NR/NA Containment Improvement

Concept of Upgrade Solution

Solution concept

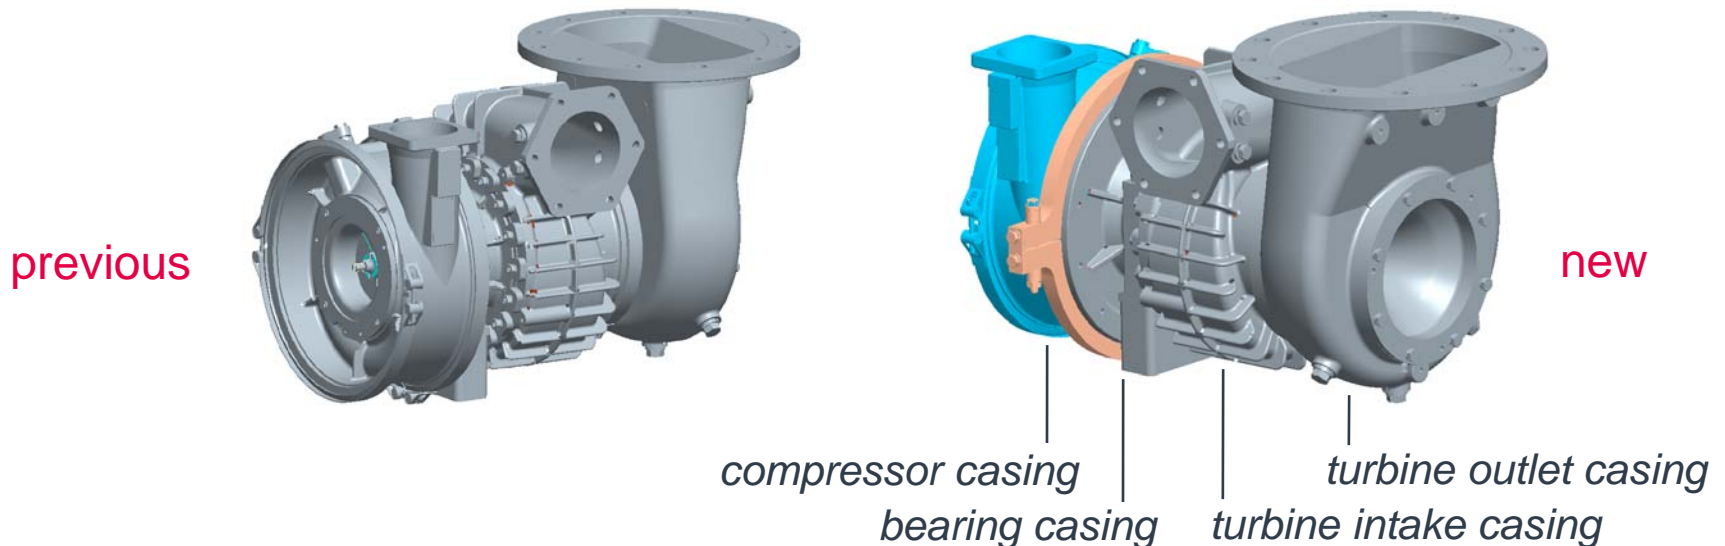
With NR and NA turbochargers, the casings and/or the flange connections are not sufficiently strong to withstand extreme load situations which may for example occur in the very rare case of a rotor failure.

- Modification of the casing design (compressor casing, insert piece)
- Modification of connection of compressor and bearing casing
- Scope (number of components) varies per turbocharger type
